Access Compliance Report

Public Rights-of-Way

Intersection ID: 9610	Main Street: BARRINGTON_DR	Cross Street: THE_PLAZA	Location: W
ADA ID: 3BA9FB4C314B	Ramp Type: PerpDiag	Initial Pass/Fail: Fail	Overall Compliance: No
Severity Score: 12.5			
Codes/Mitigation Info/Possible Solution		Field Measurements/Component Compliance

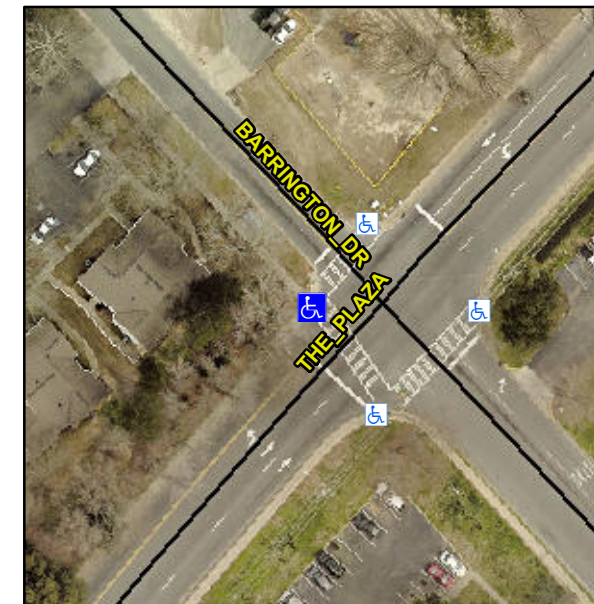
Not Found, R304.2.2

Compliance	Description	Data	Compliance	Description	Data
N/A	Ramp Length (in)	48.0	No	Ramp Slope (%)	10.9
Yes	Ramp Width (in)	48.0	Yes	Ramp XSlope (%)	1.1
N/A	Flare Type LT	N/A	N/A	Flare Type RT	N/A
N/A	Flare Slope LT (%)	N/A	N/A	Flare Slope RT (%)	N/A
N/A	Flare Traversable LT?	N/A	N/A	Flare Traversable RT?	N/A
N/A	Landing Length (in)	N/A	N/A	DWS Provided?	N/A
N/A	Landing Width (in)	N/A	N/A	DWS Contrast?	N/A
N/A	Landing Slope (%)	N/A	N/A	DWS Length (in)	N/A
N/A	Landing X Slope (%)	N/A	N/A	DWS Full Width?	N/A
N/A	Landing Curb? (Y/N)	N/A	N/A	DWS Offset (in)	N/A
N/A	Shared Landing?	N/A			
N/A	Gutter Ponding?	N/A	N/A	Gutter Slope (%)	N/A
N/A	Gutter Lip Ht (in)	N/A	N/A	Gutter X Slope (%)	N/A
N/A	Painted X Walk1?	Yes	N/A	Painted X Walk2?	Yes
	X Walk 1 Direction	To SE		X Walk 2 Direction	To NE
N/A	X Walk 1 Width (in)	114.0	N/A	X Walk 2 Width (in)	109.5
	X Walk 1 Slope (%)	0.8		X Walk 2 Slope (%)	4.0
	X Walk 1 X Slope (%)	2.4		X Walk 2 X Slope (%)	0.7

Remove & Replace Curb Ramp With Two New Directional Ramps or Equivalent.
